RESIDENTIAL ENGINEERING SERVICES, LLC.
SHOP DRAWINGS/SUBMITTAL REVIEW

JOB No.	2592336
DESCRIPTION	SUMMIT HOMES - WOODSIDE RIDGE #16
JOB ADDRESS	2035 NW ASHURST DR
CITY	LEE'S SUMMIT, MO
DESIGNER	TODD W MOORE
DATE	12/31/2020

ROOF
TRUSS LAYOUT

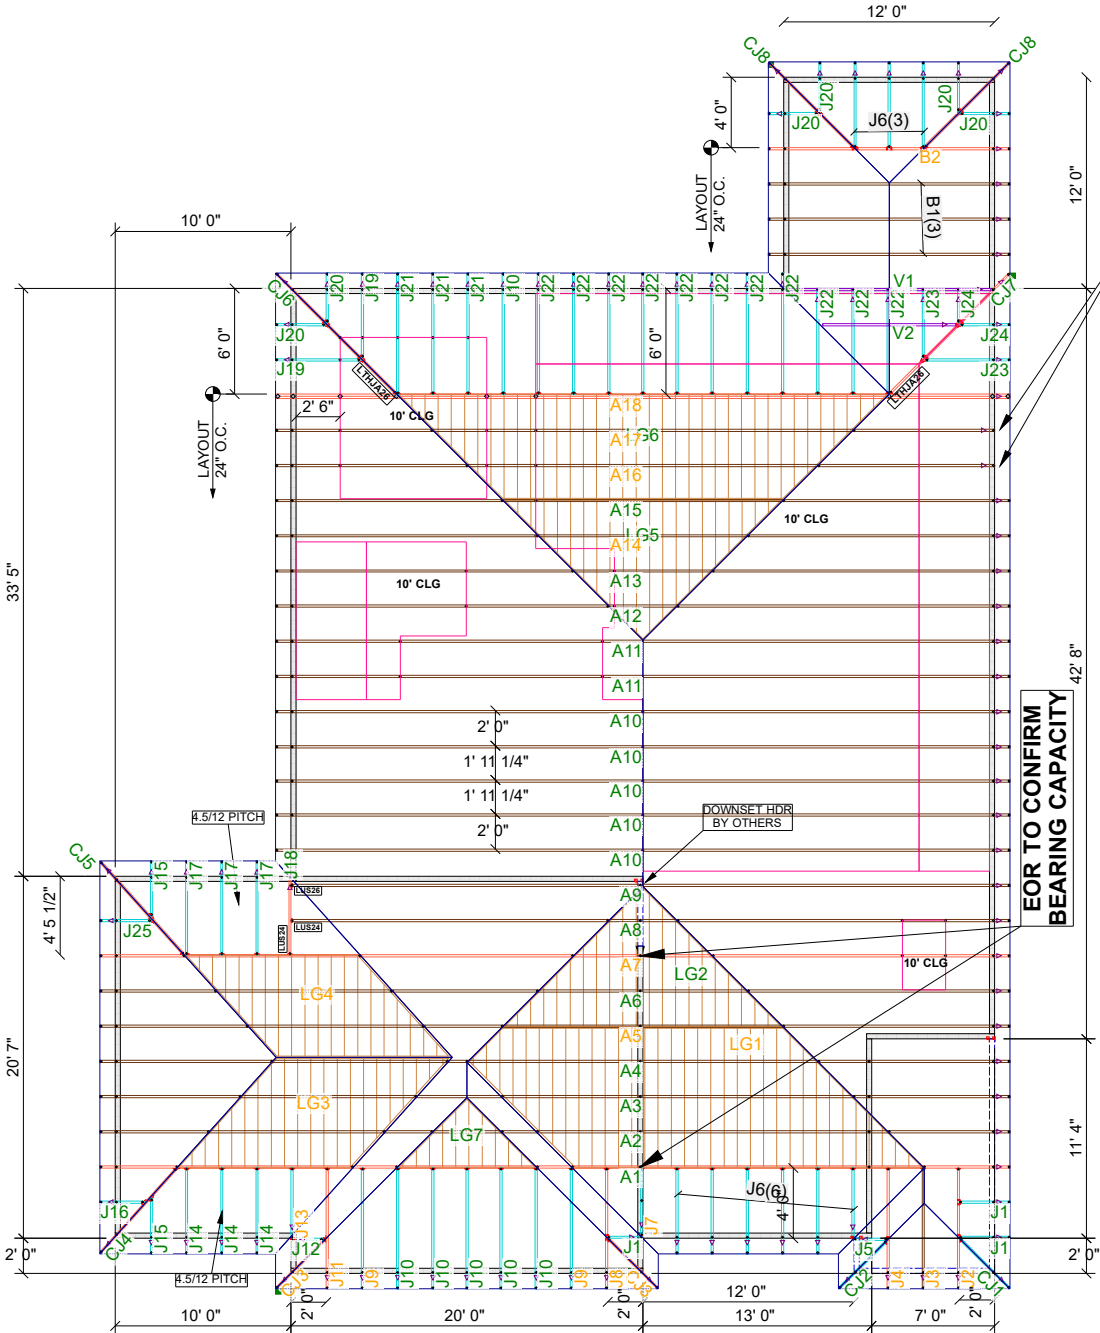
ATTACH PROVIDED
2X8 SCAB PER
ENG DWG NOTES
